**Comments on Public Registry File: 5991.00 - Canadian Premium Sand Inc.
Environmental Act Proposal - Wanipigow Sand Extraction Project
Submitted by Don Sullivan on behalf of What The Frack Manitoba Inc.**

February 11, 2019

Figure 1 Project layout showing water bodies that may be affected by the Project including two unnamed creeks draining the southern Project area. **Figure 1** is reproduced from the AECOM EAP (Figure: 1-1).

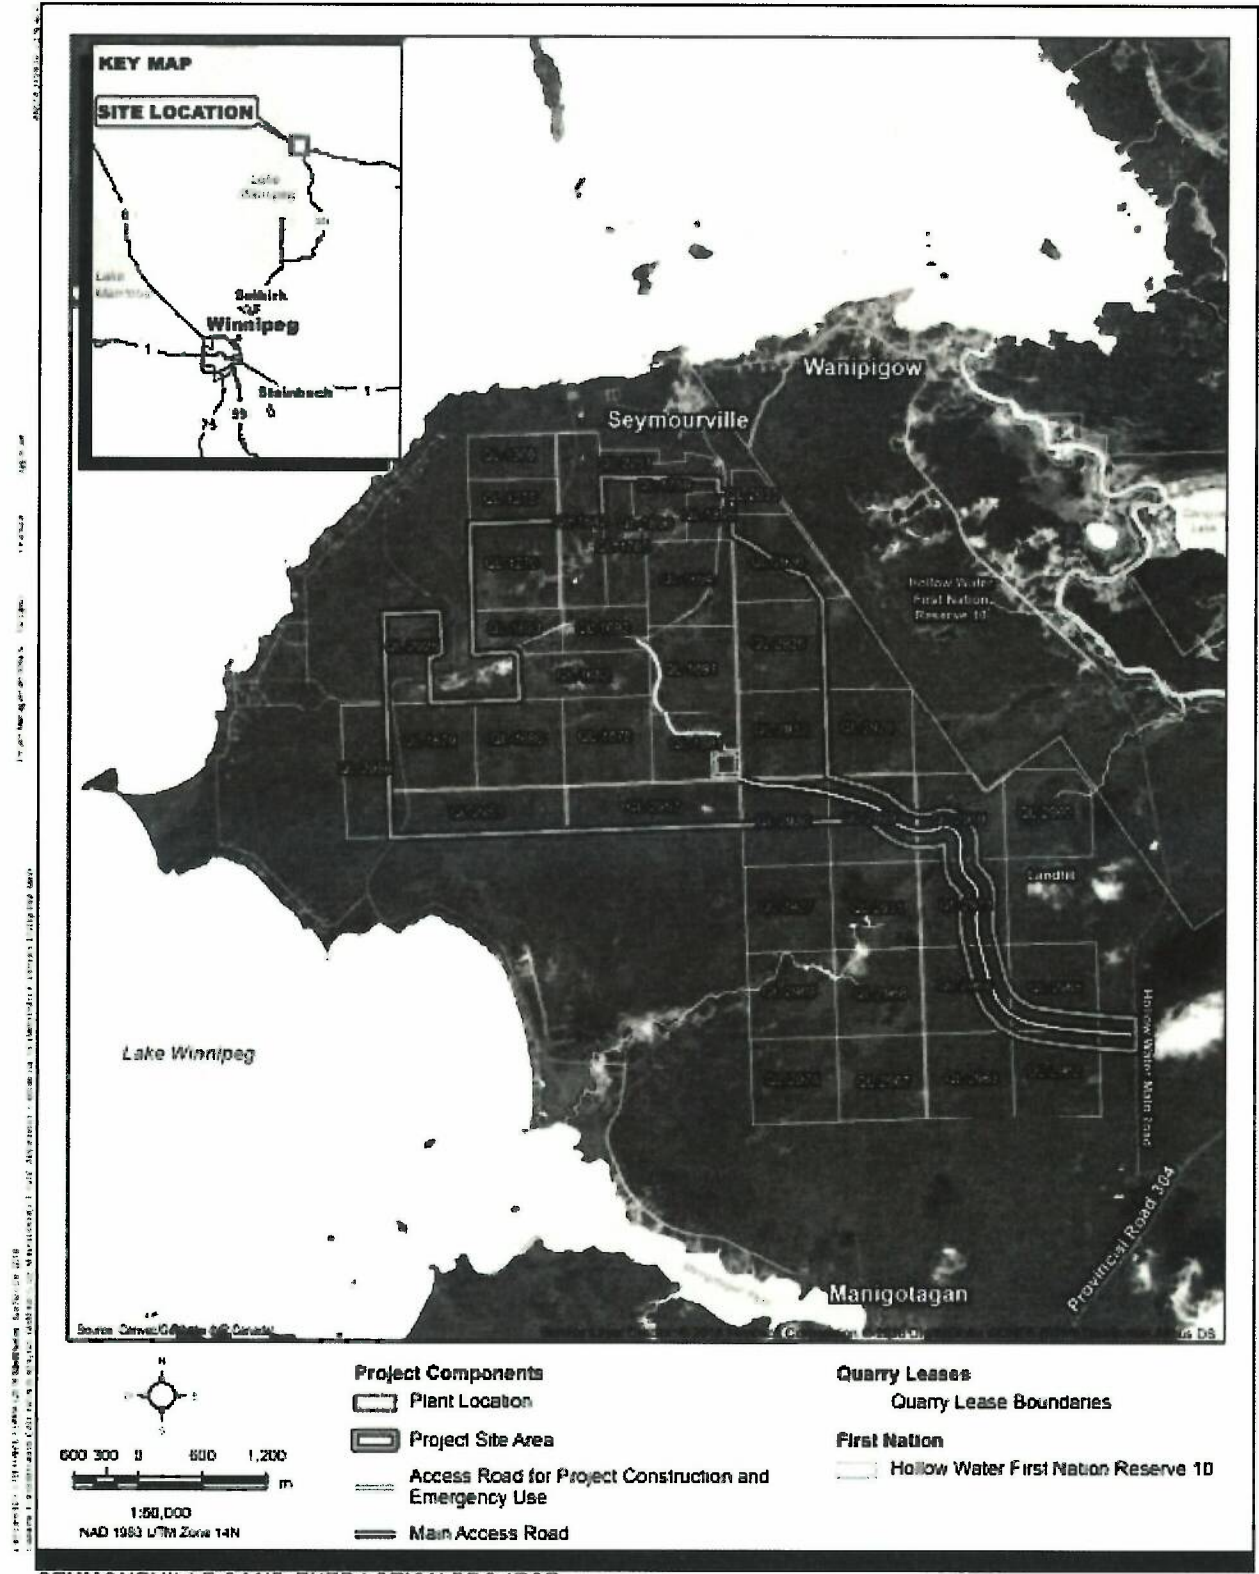
The fish and fish habitat that may be affected by the Project include sections of the Wanipigow River, Manigotagan River mouth, Lake Winnipeg and two unnamed Creeks shown in **Figure 1**.

The unnamed creeks have not apparently been evaluated for fish, and fish habitat. Such an evaluation should be made as part of this Project as the water flow and fish habitat in these creeks may be adversely by drainage from the Project. Portions of the unnamed creeks are within the quarry lease boundaries of the Project as shown in **Figure 1**. Should there be fish habitat within these creeks, the claim in the AECOM EAP that there is no fish habitat within the Project site would be inaccurate.

Figure 2 Pyritic shale layer overlying the sand deposit on Black Island

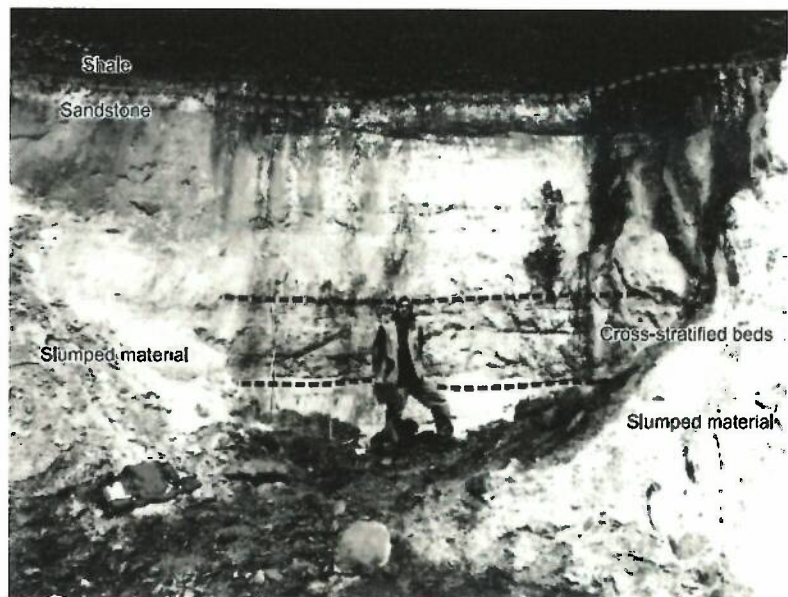
The shale layer and sulphide staining from dissolution of the pyrite in the overlying shale is illustrated in **Figure 2** reproduced from the 2016 Report.

Figure 3 Process flow sheet for wet plant from Appendix A of AECOM EAP showing three sand stockpiles each 70 meters in height with two having a 140 meter base and the third a 325 meter base

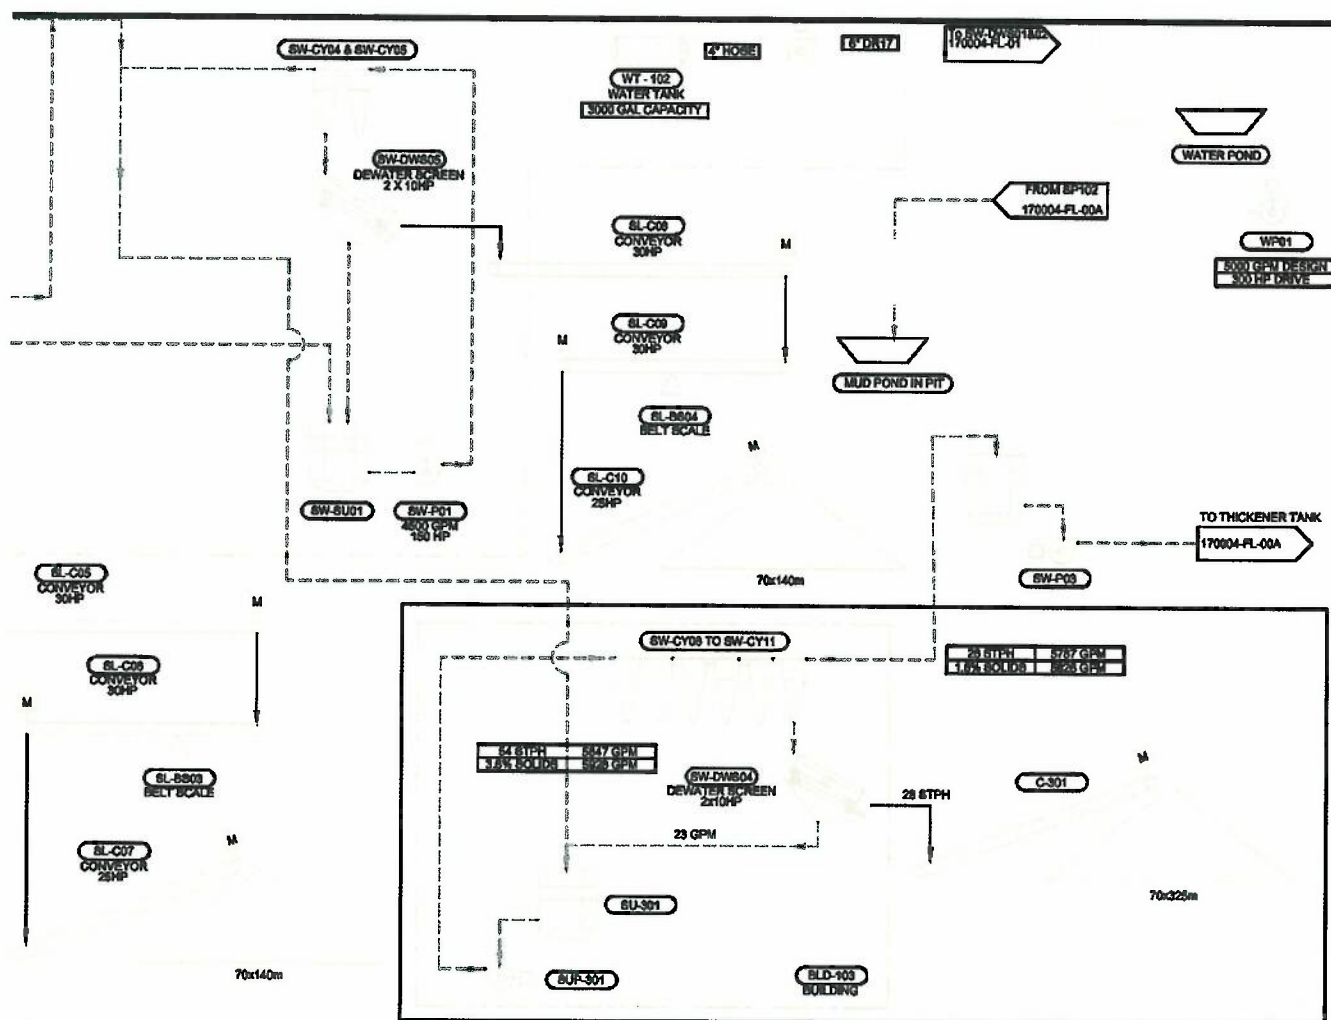
In Wanipigow the sand deposit is below the water table and will not be quarried in winter. A propane heated winter storage plant to hold 250 000 tonnes of wet sand destined for the wash plant from the quarry is described in the CPS Technical Report. No mention of a large heated winter wet sand storage plant is made in the AECOM EAP. However, three large 70 meter high outdoor sand stockpiles are shown in the process flow sheet for the wet plant in appendix A of the AECOM EAP reproduced in Figure 3.

Another potential source of process water discharge into nearby water bodies that can impact fish habitat is from the water settling pond. The location and size of this pond is not given in the AECOM EAP. It is appears as a small tray labelled “*water pond*” in the process flow sheet of the wet plant as shown in **Figure 3**.

A third major source of silica dust excluded from the modelling is wind blow dust from three 70 meter high sand stockpiles on site as shown in **Figure 3** which is an excerpt from the process flow sheet of the wet plant given in appendix A of the AECOM EAP (<http://www.mfe.govt.nz/sites/default/files/media/Air/good-practice-guide-dust-2016.pdf>).

It should also be mentioned that the safe angle of repose has not been considered for the stockpiles. The two stockpiles having a base of 140 meters would have a slope angle of 45° which is above the angle of repose for dry sand of 34° (https://en.wikipedia.org/wiki/Angle_of_repose). Sand slide may endanger workers (https://www.hsa.ie/eng/Your_Industry/Quarrying/Stockpiles_Tips_and_Lagoons/Management_of_Tips_and_Stockpiles/). This is another example of the lack of due diligence and planning by the proponent pertaining to worker safety and human health.

Figure 6 Registered traplines in the Wanipigow area

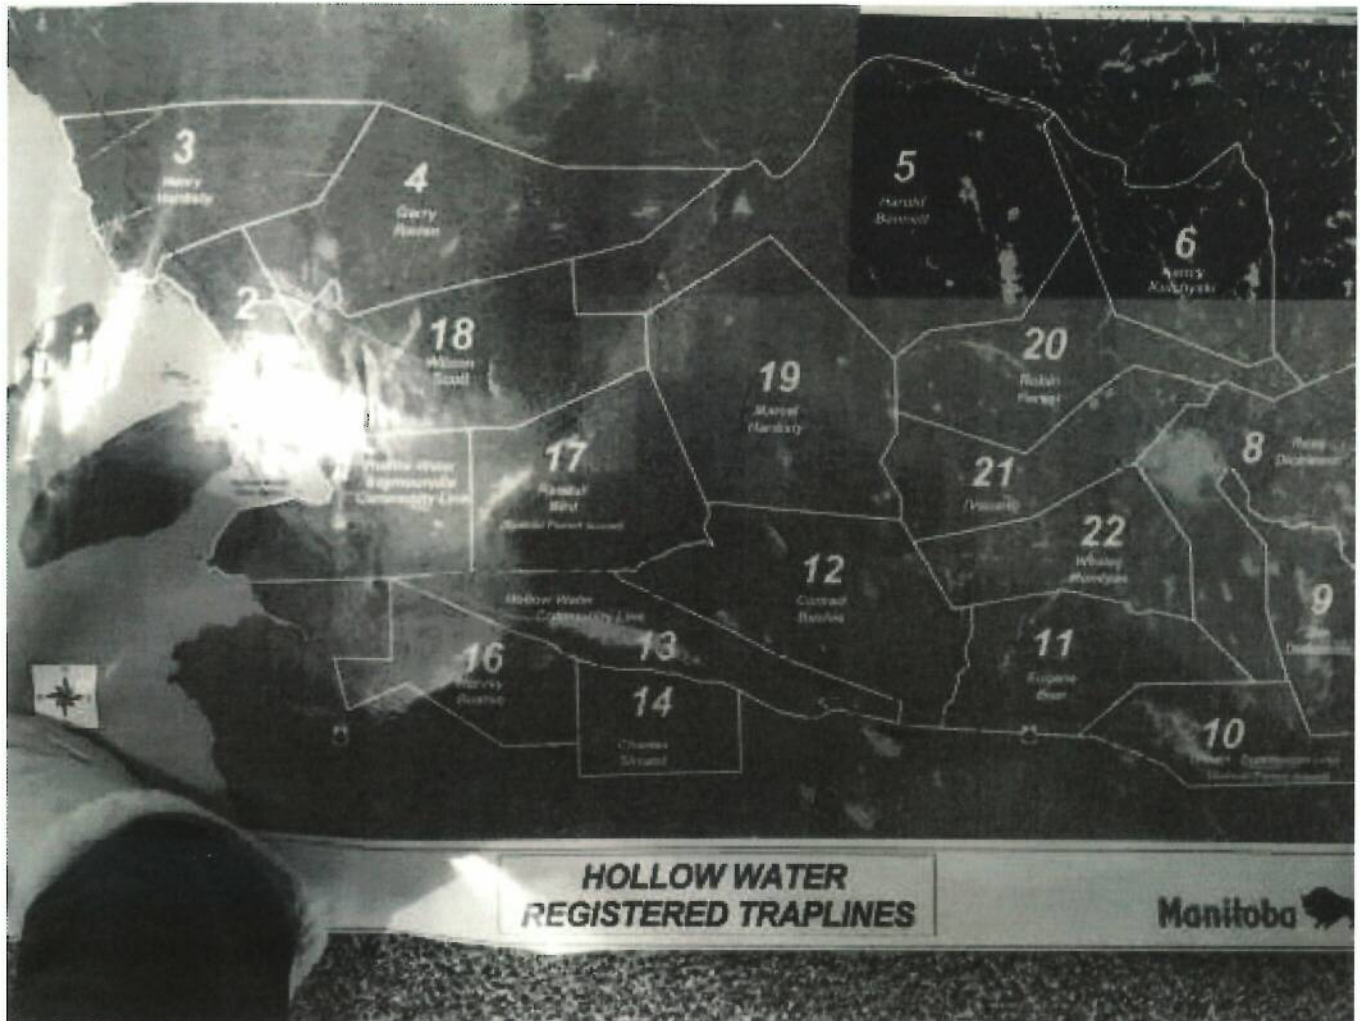
Figure 6 shows the registered traplines in the Wanipigow area. The Hollow water Seymourville Community Trapline will be adversely affected by the Project. This disruption in itself should trigger an assessment.

Figure 7 Dust Collection from two Bag Houses and all Dry Plant Building

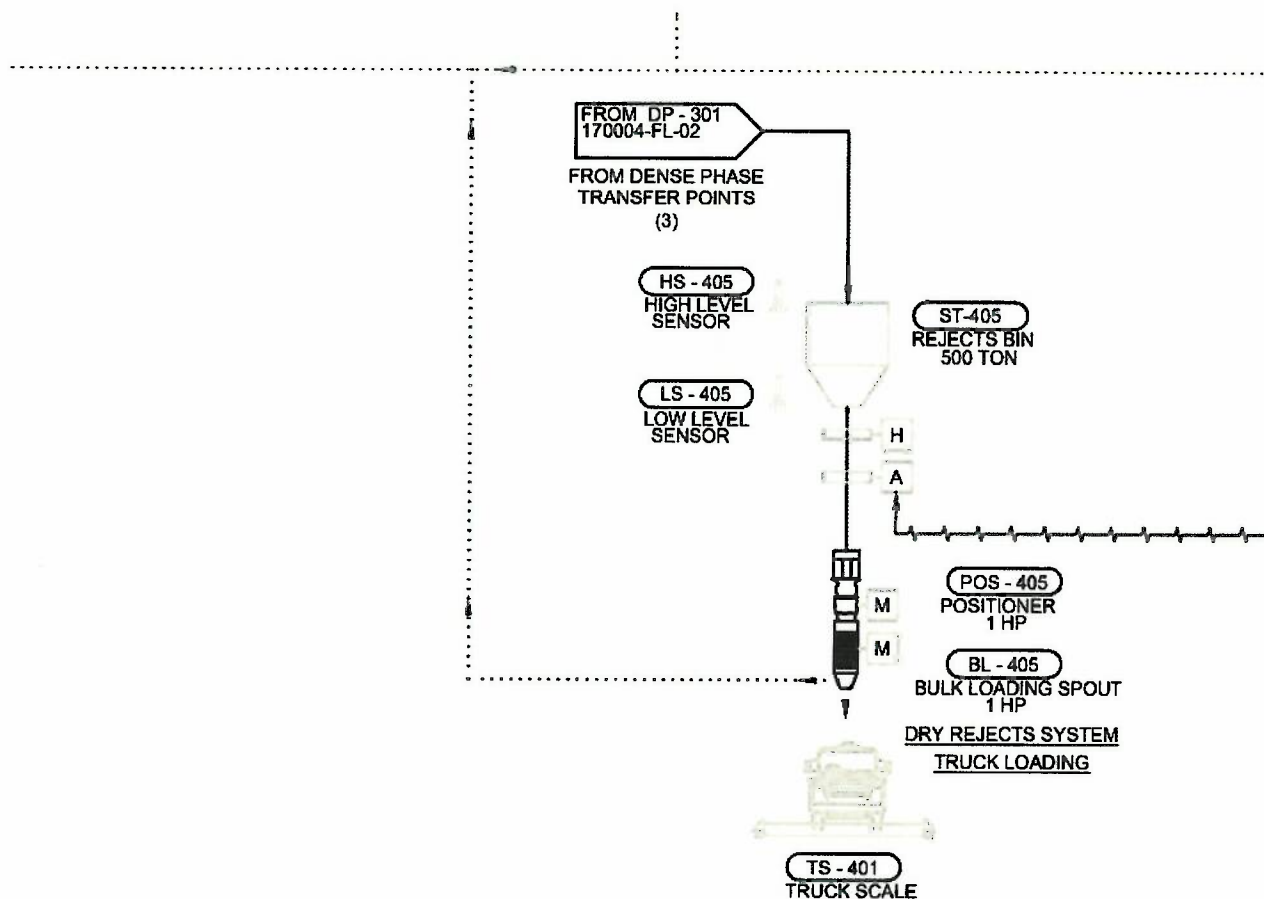
The onsite disposal of dust from the two bag houses and from the dry plant dust collection system routed to a 500 ton rejects bin is not included in the model source. The rejects bin is shown in Figure 7 taken from an excerpt from the process flow sheet of the storage and loading area of appendix A of the AECOM EAP. Output from the 500 ton rejects bin is shown to be split with some loaded on a truck and some routed off page. The off page route is likely onsite disposal as is the practice in silica mines in Wisconsin (<https://dnr.wi.gov/topic/Mines/documents/SilicaSandMiningFinal.pdf>). Onsite disposal of dust in the 500 ton reject bin may create large amounts of airborne respirable PM2.5 and PM10 that would be a hazard to workers and surrounding communities. The destination of trucks loaded with respirable silica dust is not described. Unloading of the trucks may involve a risk of exposure to silica dust.
